**SUBJECT: ADDITIONAL INFORMATION ON GROUND WATER MONITORING**

Combustion Engineering, Inc.

**RESPONSE TO REQUEST FOR ADDITIONAL INFORMATION ON GROUND WATER MONITORING PLAN FOR THE HEMATITE FACILITY**

Figure 1. Location of Sampling Wells For Burial Site (Revised)

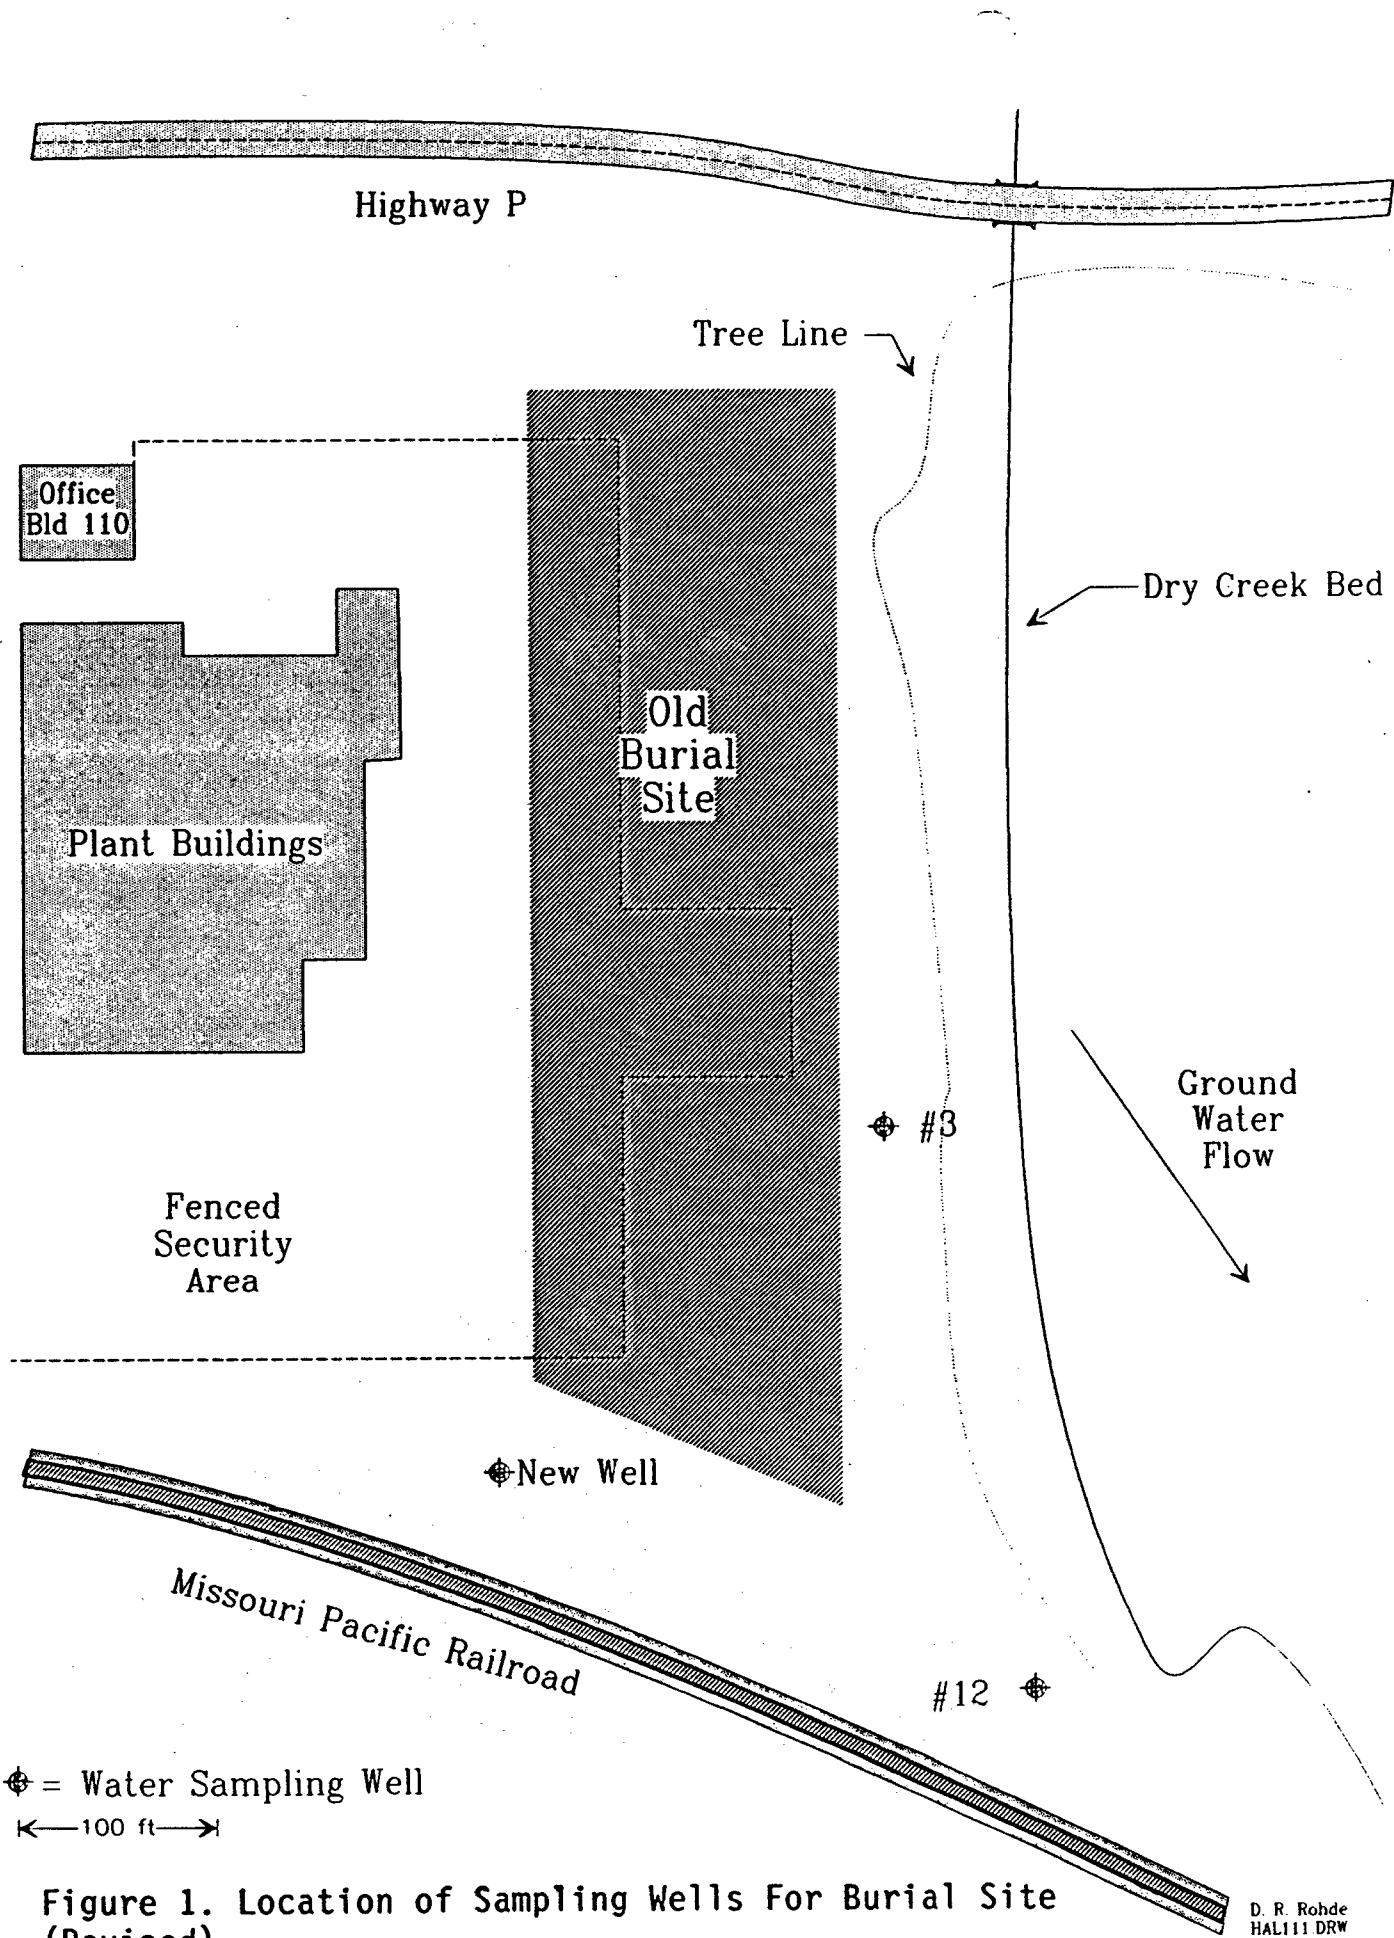
1. In place of Figure 1, provide a figure that shows the actual location of the burial ground and the direction of ground water flow.

Figure 1 has been revised to show the location of the old burial site and to indicate the direction of ground water flow.

Figure 2 (Rev.)

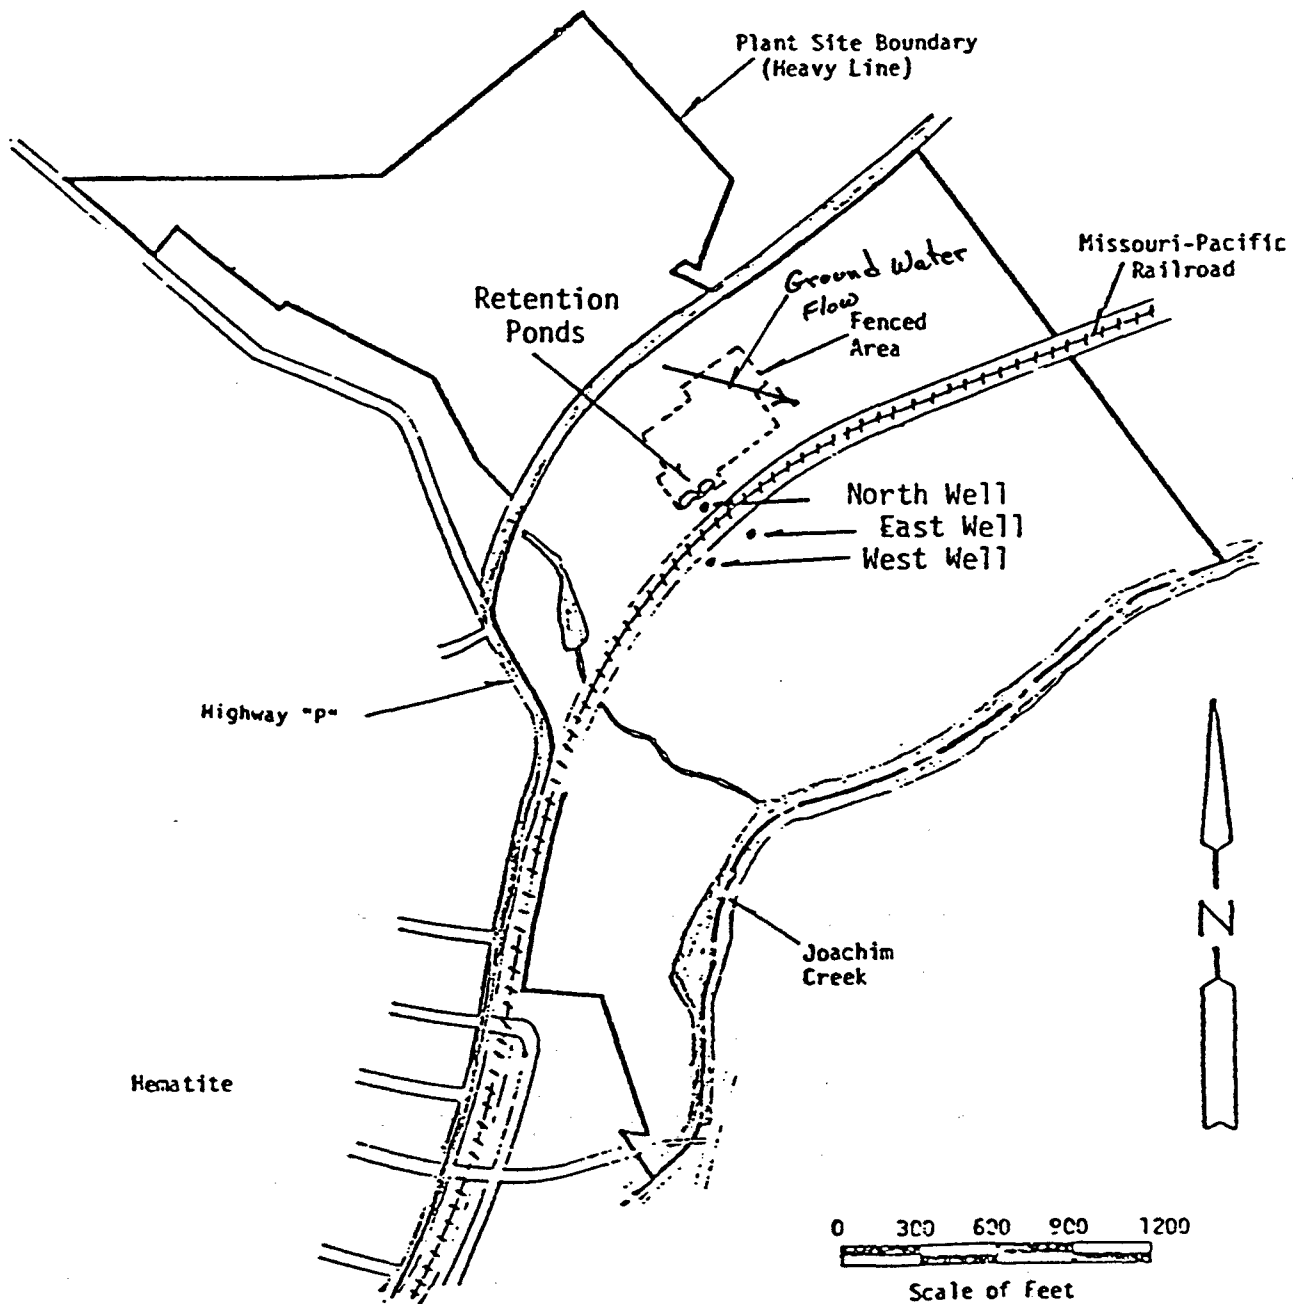
3. Indicate on Figure 2 the direction of ground water flow.

The direction of ground flow (ESE) has been indicated on Figure 2.

Figure 3 (Rev.)  
Locations of Limestone Piles

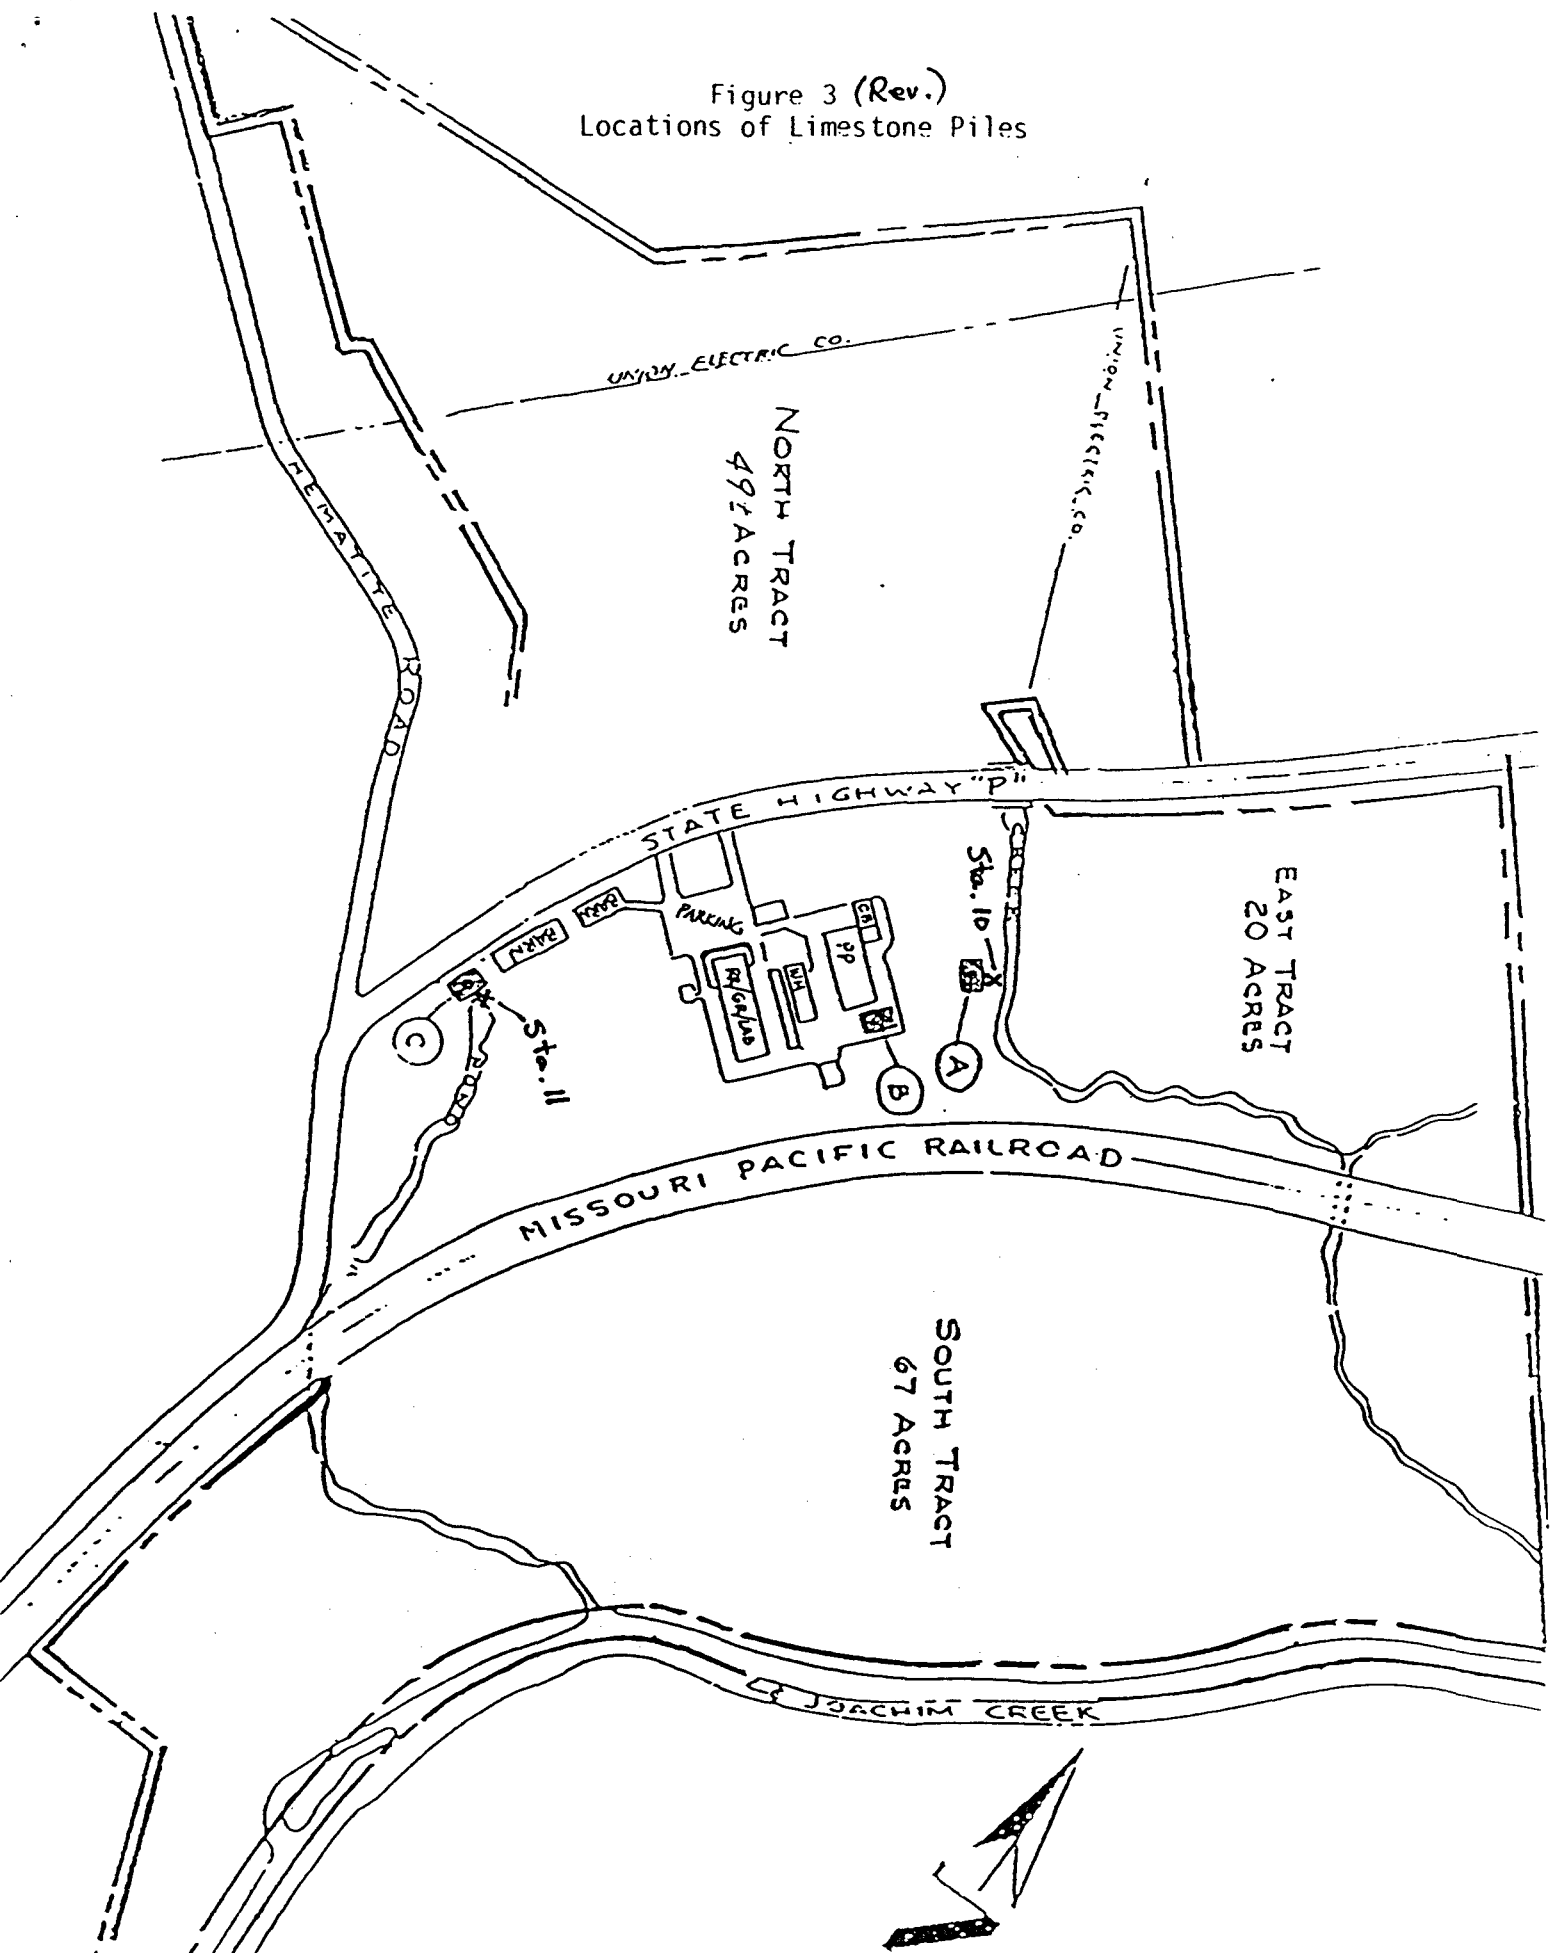
## 5. Indicate on Figure 3 the location of sampling stations 10 and 11.

## 7. Include Pile B in the sampling program.

Soil sampling stations 10 and 11 have been indicated on Figure 3.

Spent limestone Pile B will be included in the soil sampling program, beginning with the fourth quarter 1990 sample collection.

Figure II. 1-4

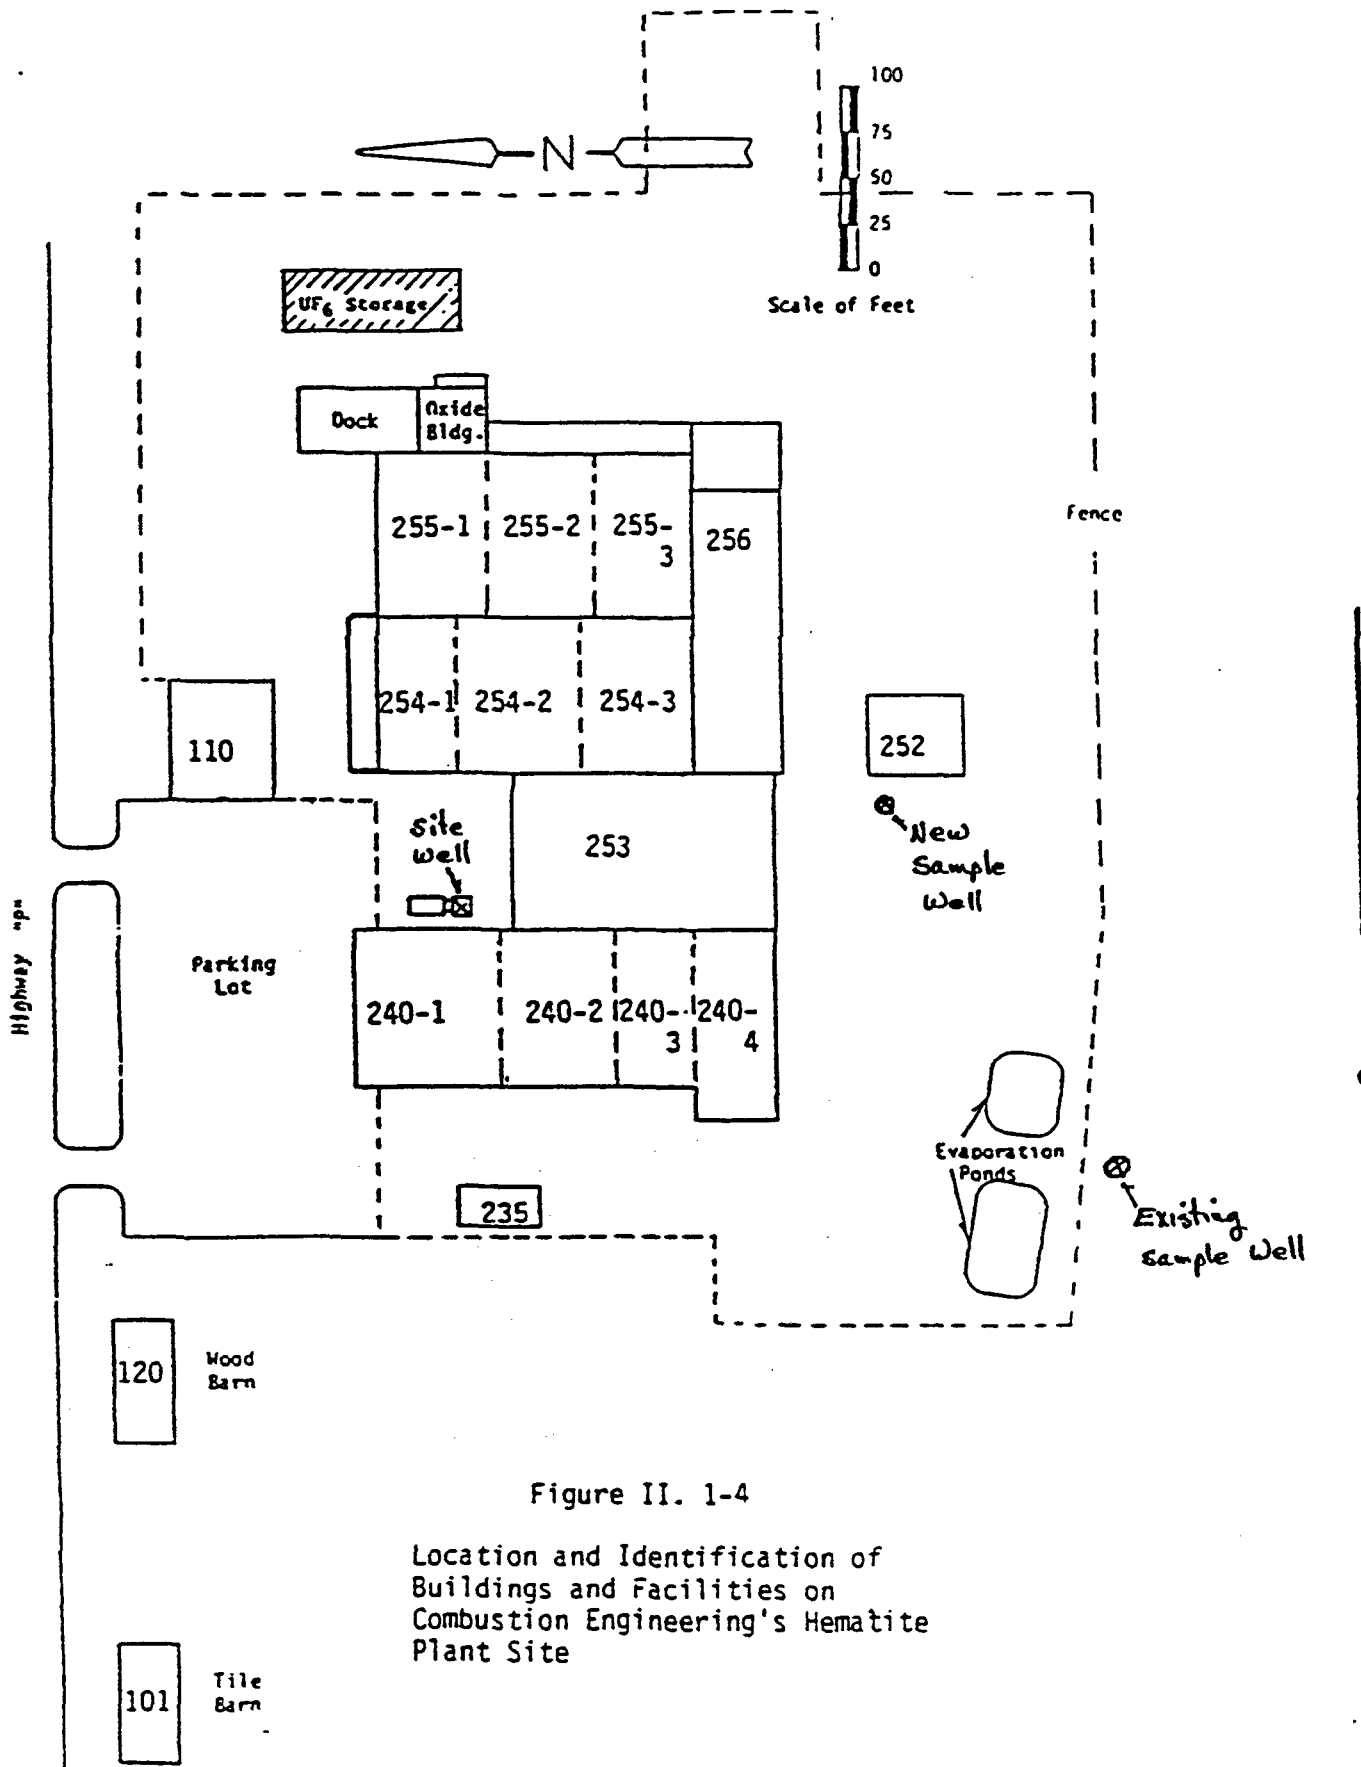
We also plan to add a new ground water sampling well to monitor for contamination from the Building 240/253 area, as shown on Figure II.1-4. Weather permitting, this well will be installed during October, 1990, and sampled on a monthly frequency.
